# MCF5475 Reference Manual Errata

This errata document describes corrections to the *MCF5475 Reference Manual*, order number MCF5475RM. For convenience, the addenda items are grouped by revision. Please check our website at <http://www.freescale.com/coldfire> for the latest updates.

The current version available of the *MCF5475 Reference Manual* is Revision 5.

**Table 3. MCF5475RM Rev 2.1 Errata**

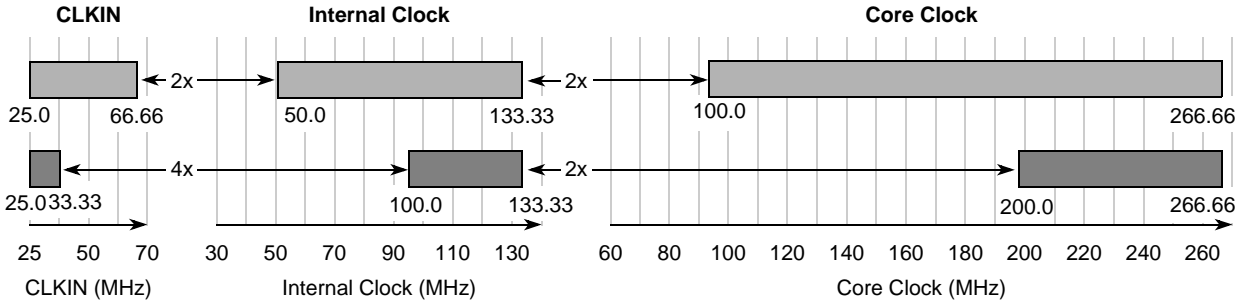
Location	Description
Throughout	Replace all instances of MAPBGA with PBGA, as this is the correct package that the devices are available in.
Figure 2-1/Page 2-2	<ul style="list-style-type: none"> <li>• Replace all PPSC1PSC0n entries in the figure with PPSC1PSC0n. There is no PPSC1 port.</li> <li>• <u>PSC0CTS</u> pin: Change GPIO entry from PPSC1PSC2 to PPSC1PSC03.</li> <li>• <u>PSC0RTS</u> pin: Change GPIO entry from PPSC1PSC3 to PPSC1PSC02.</li> <li>• <u>PSC1CTS</u> pin: Change GPIO entry from PPSC1PSC6 to PPSC1PSC07.</li> <li>• <u>PSC1RTS</u> pin: Change GPIO entry from PPSC1PSC7 to PPSC1PSC06.</li> <li>• <u>PSC2CTS</u> pin: Change GPIO entry from PPSC3PSC2 to PPSC3PSC23.</li> <li>• <u>PSC2RTS</u> pin: Change GPIO entry from PPSC3PSC3 to PPSC3PSC22.</li> <li>• <u>PSC3CTS</u> pin: Change GPIO entry from PPSC3PSC6 to PPSC3PSC27.</li> <li>• <u>PSC3RTS</u> pin: Change GPIO entry from PPSC3PSC7 to PPSC3PSC26.</li> </ul>
